Final
Environmental Impact Report
Chula Vista Woods
EIR-84-6
SCH#84021505

This chapter contains the comments and the responses to the comments received during the public review period of May 10, 1984 to July 25, 1984 as well as public testimony taken at a Planning Commission hearing held on July 25, on the Chula Vista Woods Draft Environmental Impact Report (SCH 84021505). All comments received from the City of Chula Vista staff and other reviewing parties are discussed herein. This chapter, along with the preceding ten chapters, constitutes the Final Environmental Impact Report.

Figure 5

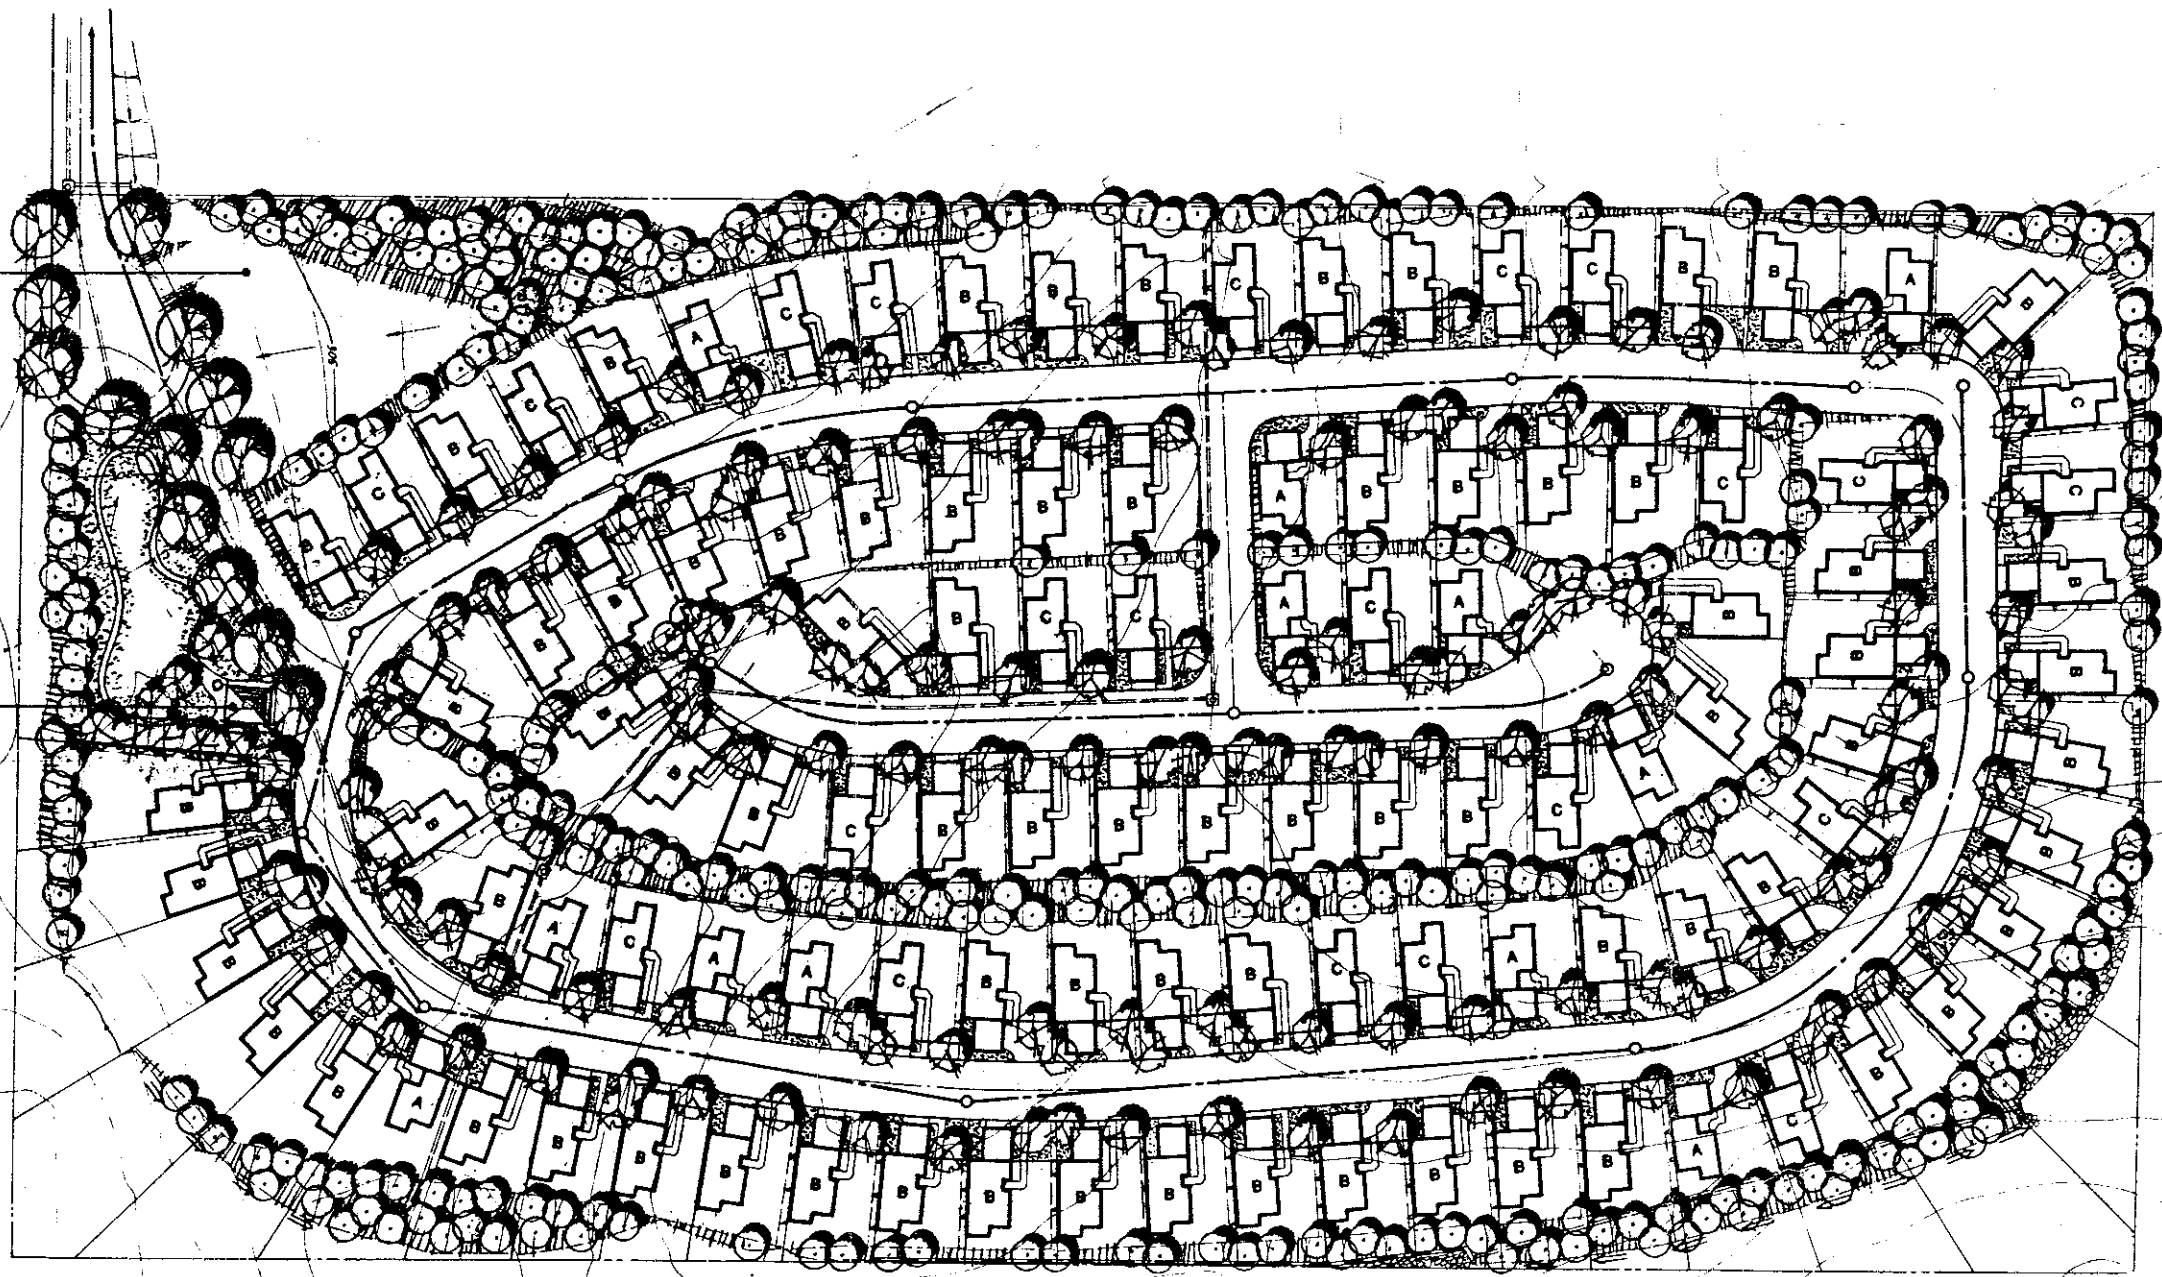
Page 3 and Figure 5 of the EIR disclose that the proposed project will include a recreational vehicle storage area underneath the high voltage transmission line, which crosses the project site in its northwest corner.

Figure 8

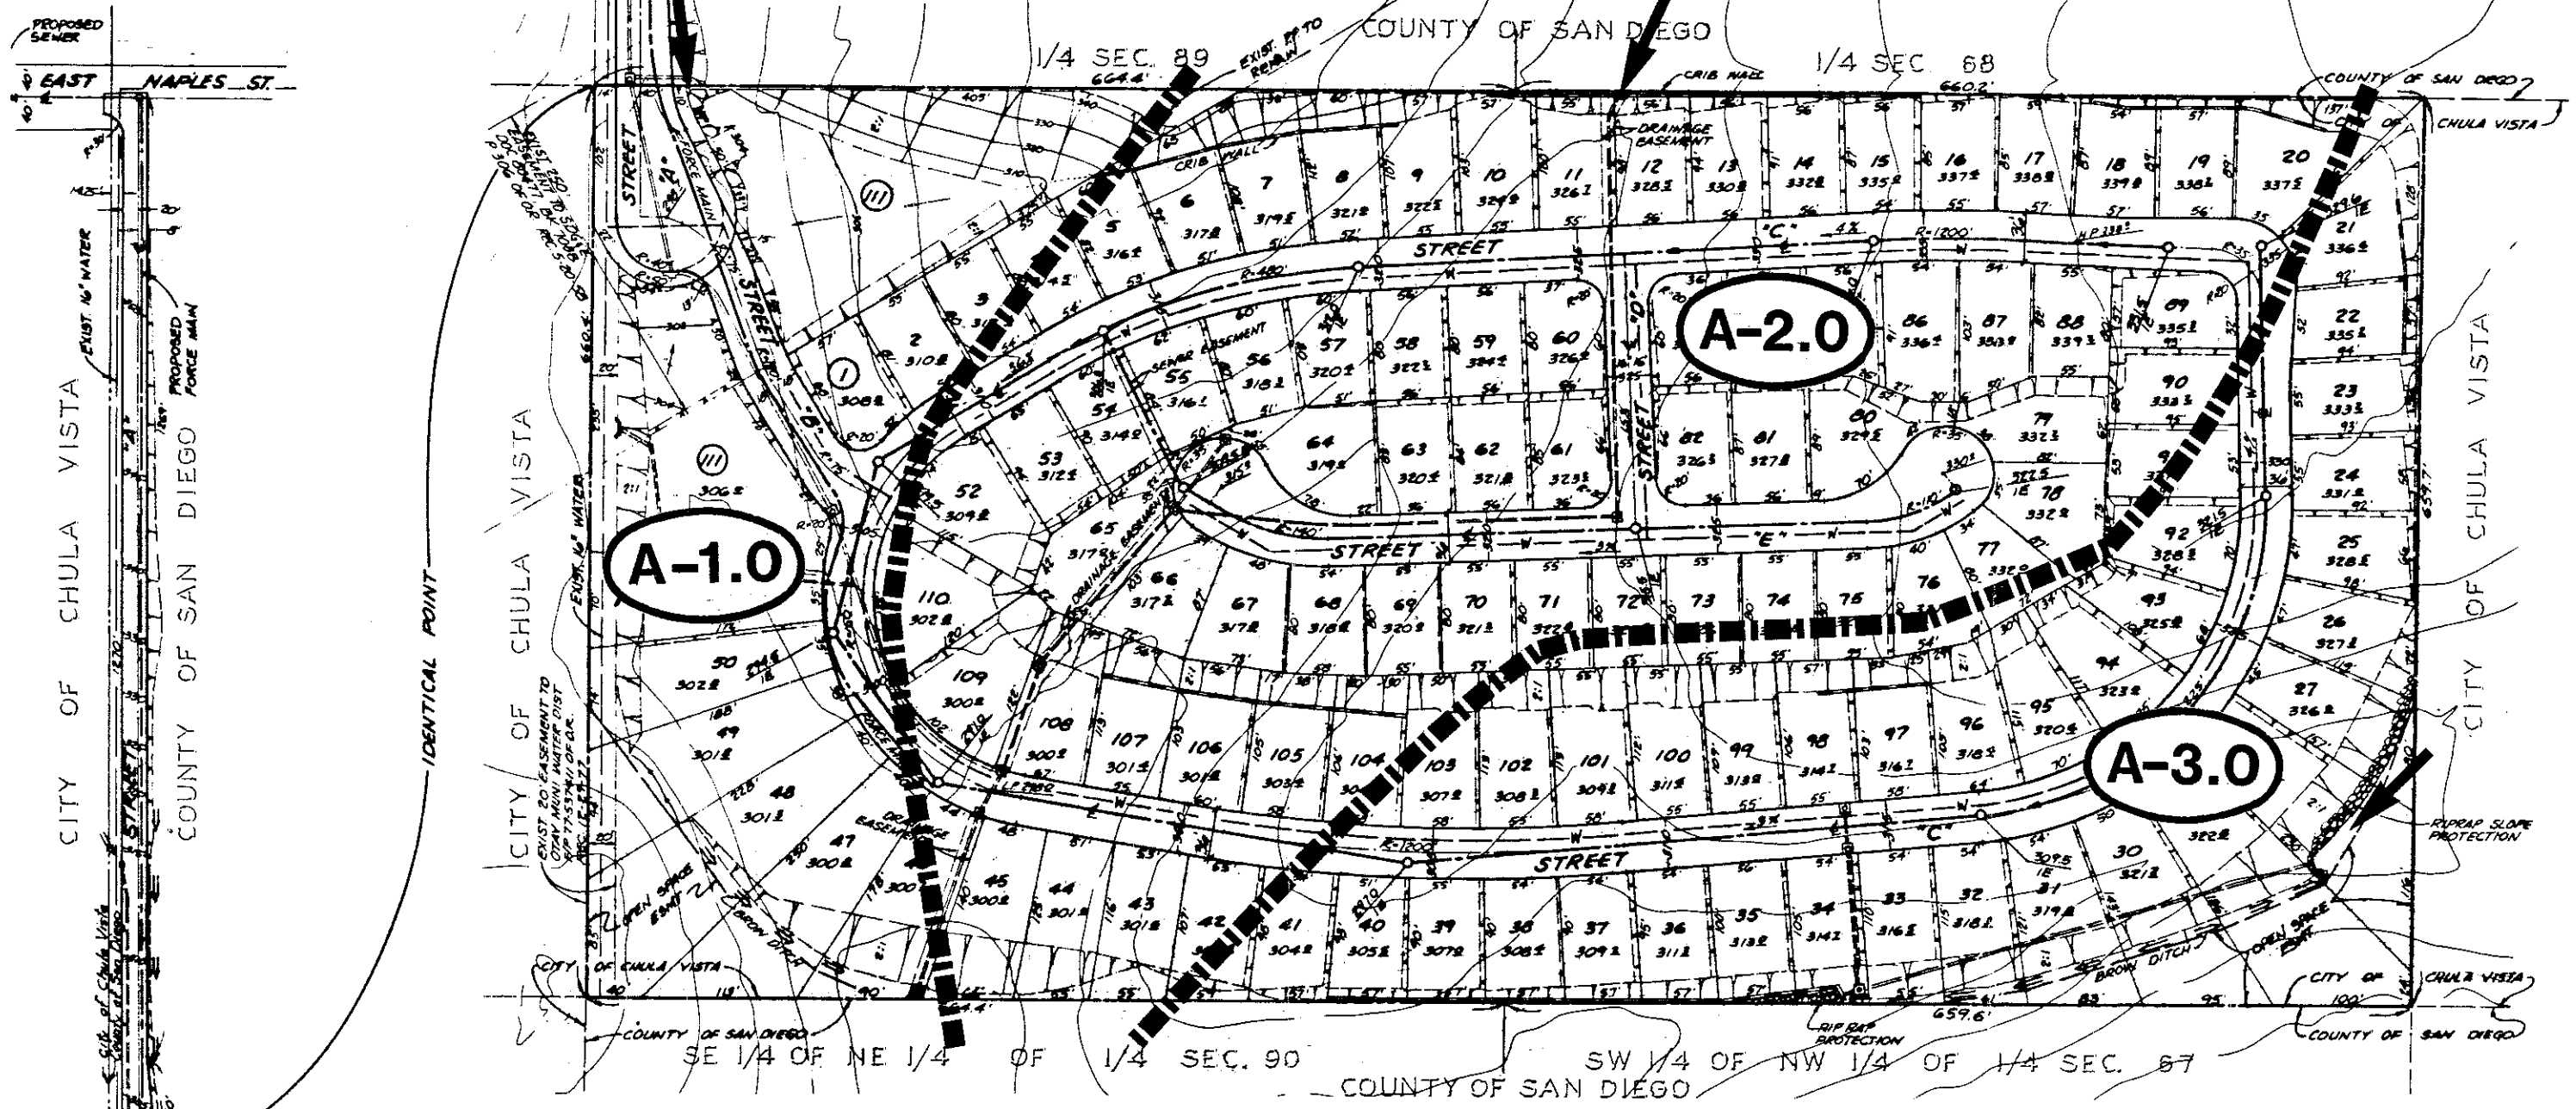
Figure 8 in the EIR indicates the proposed on-site drainage. It shows, in the southwest corner of the project, drainage being dumped onto United Enterprises' property via a brow ditch with no mitigation. At the south end of the property, near the southwest corner, it shows drainage dumped down a very steep embankment onto a small amount of rip-rap, onto United Enterprises' property.

There are feasible alternatives to the system shown on Figure 8. For example, a detention basin at the southeast corner of the project will be needed to mitigate impacts. The storm drainage system can be reoriented to lessen impacts offsite. If lots 47 - 50 and lot 111 are developed, a detention basin at the southwest corner will be necessary to mitigate impacts. If lots 47 - 50 and lot 111 are preserved for biological reasons (See biological section of the EIR, pages 20 - 26 and Appendix C), then the runoff can be dissipated evenly along the southwest side of "C" Street, and it will at the same time provide more water for the biological resources.
